AMENDMENTS TO DRAWINGS

REMARKS

ANNOTATED DRAWING

Fig.2.

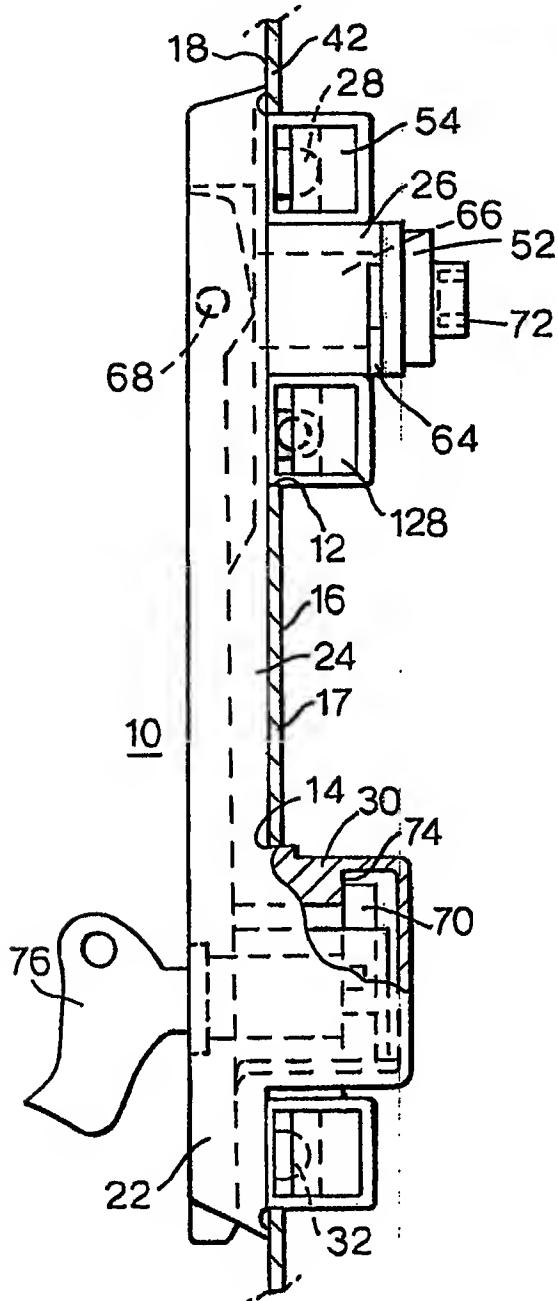
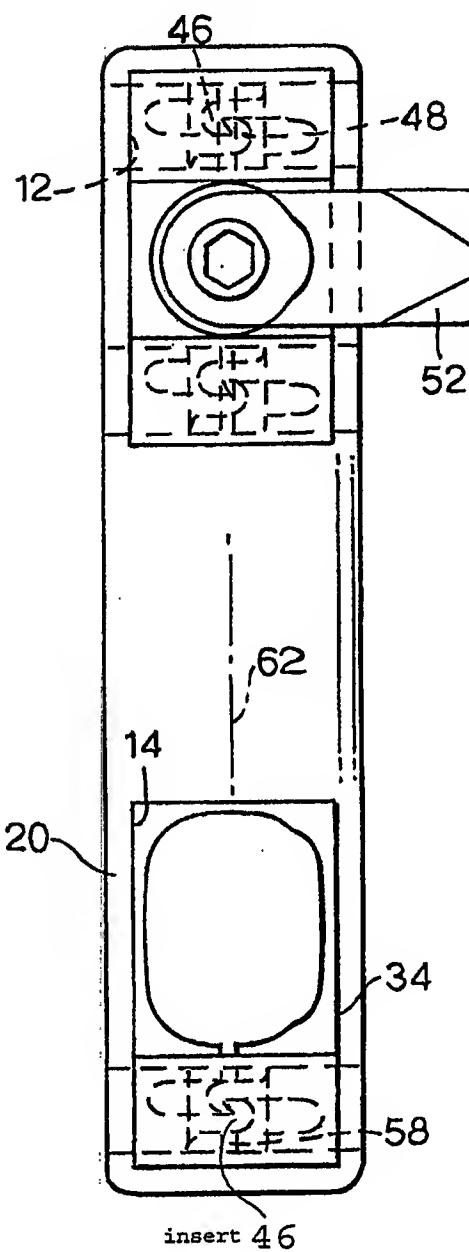
Fig. 2: 46

Fig. 3: 12, 18, 20, 40, 41, 54, 61

Further, Applicants remove reference number 28 from Fig. 3.

1. The opening (of claims 28 and 31) is shown at least by reference number 12 (see, e.g., Figure 3) and is described by the specification at least in the Abstract.

2. The rim of the opening (of claims 28 and 31) is shown at least by reference number 20 (see, e.g., Figure 3) and is described by the specification at least in the Abstract.

3. The holding elements in a cylinder (of claims 28 and 31) is shown at least by reference number 36 (holding element) and 54 (cylinder) and is described by the specification at least at by paragraph [0013] of the application and was shown in original Figure 3.

5. The pin arrangement including screws (of claims 31 and 32) is shown at least by reference number 41 and is described by the specification at least at paragraph [0016] of application and shown in original Figure 3.

Fig.8A.

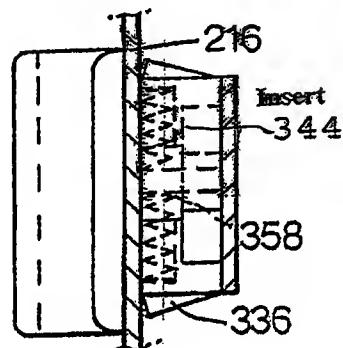
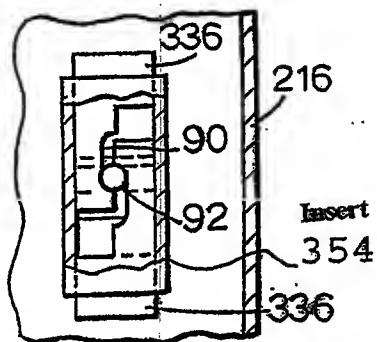
Fig. 8A: 344

Fig. 8B: 354

Fig.21.

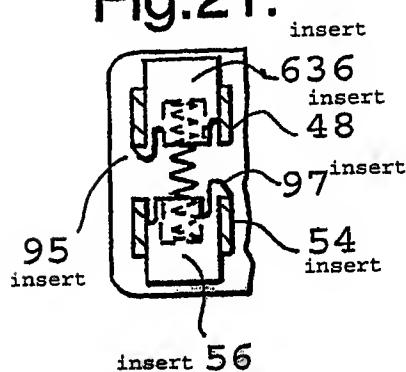
Fig. 21: 48, 54, 56, 95, 97, 636

4. The hook arrangement locking between the cylinder (of claim 29) is shown at least by reference number 97 (hook) and 54 (cylinder) and was shown in original Figure 21.

6. The undercut of the cylinder (of claim 34) is shown at least by reference number 95 (see, e.g., Figure 21) and is described at least by paragraph 17 of the application.
